RS-14-316

Peach Bottom Atomic Power Station, Units 2 and 3
Renewed Facility Operating License Nos. DPR-44 and DPR-56
NRC Docket Nos. 50-277 and 50-278

Quad Cities Nuclear Power Station, Units 1 and 2
Renewed Facility Operating License Nos. DPR-29 and DPR-30
NRC Docket Nos. 50-254 and 50-265

Subject: Response to Request for Additional Information - Proposed Alternative to Utilize Code Case N-513-3, "Evaluation Criteria for Temporary Acceptance of Flaws in Moderate Energy Class 2 or 3 Piping Section XI, Division 1," at a Higher System Operating Pressure

Figure 1: Required Cover Thickness vs. Adjusted Diameter for 275 and 375 psig

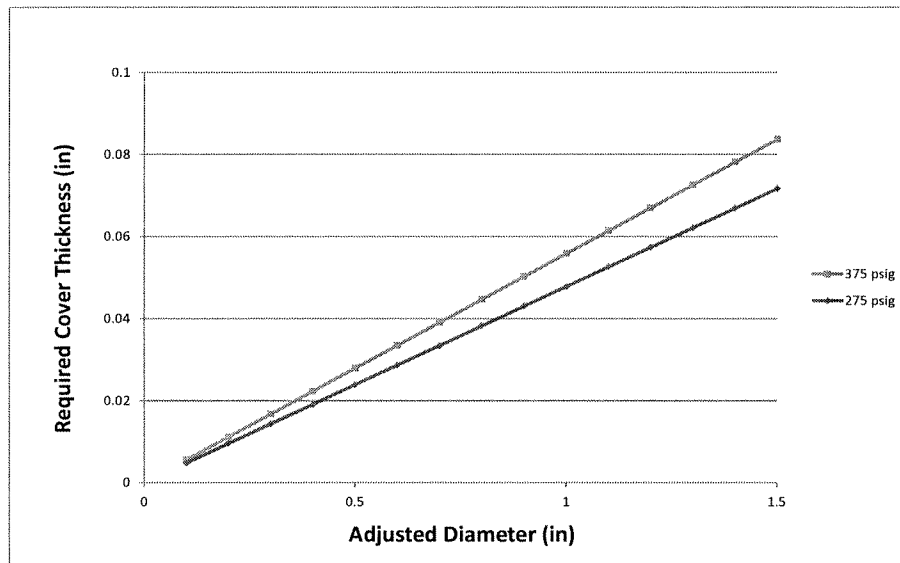
8. Page 6 of Attachment 2 discussed the average cover thickness calculated for 275 psi and 375 psi pressure. The average cover thickness and average diameter equations as specified in Code Case N-513-3 are to demonstrate acceptability under the branch reinforcement requirements. Demonstrate that a leaking pipe with a leak rate of 100 gpm at a pressure of 375 psi will satisfy the branch reinforcement requirements of Code Case N-513-3.

Exelon has reduced the allowable leak rate to the maximum allowed by evaluation or 30 gpm, whichever is lower. See below for a simplified computation for branch connection reinforcement determination in a 20-inch nominal diameter, ferritic steel pipe, that is 0.375 inch nominal wall thickness and operating at 375 psi as an example. The allowed hole diameter in this case is 1.482 inch. It should be noted that for through-wall flaws the planar flaw criteria is generally applied by evaluating the axial extent and circumferential extent as planar flaws.

Figure 2: Jet Force vs. Through-wall Hole Diameter for 275 and 375 psig

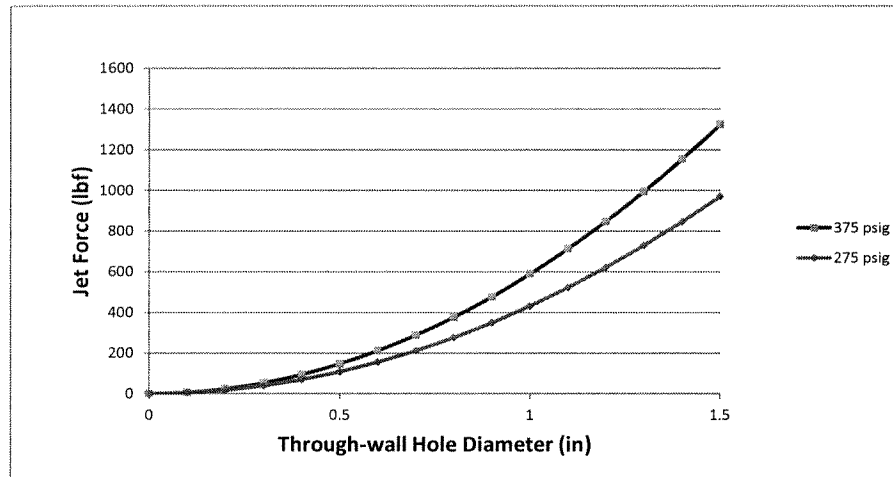
9. Page 6 of Attachment 2 discusses the result of jet thrust force calculations between a pressure of 275 psi and 375 psi. Demonstrate that the jet thrust force calculated at a pressure of 375 psi will not be detrimental to the adjacent safety-related systems, structures and components.

The evaluation process must consider requirements or commitments established for the system, continued degradation and potential consequences, operating experience, and engineering judgment. In some cases much smaller leaks than the maximum defined could be appropriate. The original relief request required that leakage be limited to the maximum allowed by evaluation or 100 gpm. Exelon has revised the relief request to require a 30 gpm maximum limit in order to add additional margin in application of this relief request. Exelon has experience with managing raw water leaks less than 30 gpm. The need to evaluate the effect on adjacent equipment is appropriate whether the system, in which the leak is occurring, is safety-related or nonsafety-related because safety-related components could be adjacent to nonsafety-related leaking pipes. The evaluation process must consider functionality of electrical equipment based on ability to resist water intrusion or actions must be taken to prevent wetting of the equipment. The ability of the adjacent area to remove the water volume must be addressed. The evaluation must consider and address all postulated negative effects of leakage regardless of pressure and conclude there are no unacceptable resultant conditions; otherwise, the leakage would be deemed unacceptable.
